COMMITTEE OF THE WHOLE DECEMBER 1, 2009

SIGN VARIANCE APPLICATION FILE NO: SV.09-021 OWNER: FIRST CAPITAL REALTY LOCATION: 9330 BATHURST STREET BLOCK 23, REGISTERED PLAN 65M-3918 WARD 1

2. Sketch of Sign

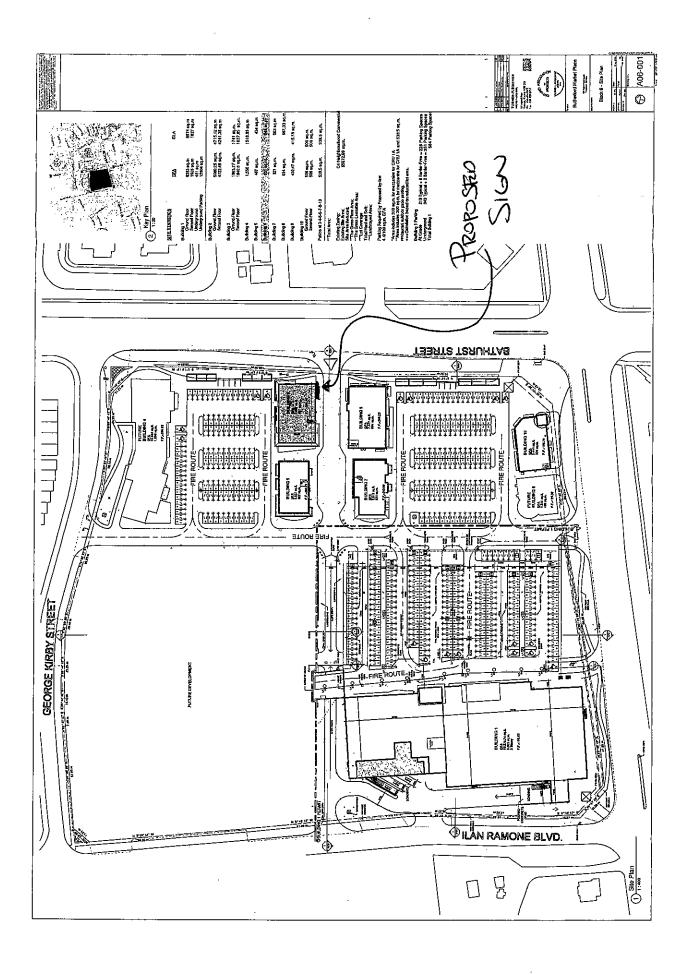
At the Sign Variance Committee Meeting revised drawings were received from the applicant revising the variance application and reducing the area of the proposed sign from 3.52 sqm. to 2.85 sqm.

Members of the Sign Variance Committee have no objections to the revised drawings/application and are of the opinion that the intent and purpose of the City's Sign By-Law is being maintained.

That Sign Variance Application SV.09-021, First Capital Realty, be APPROVED, subject to the sign being constructed in accordance with the revised drawings.
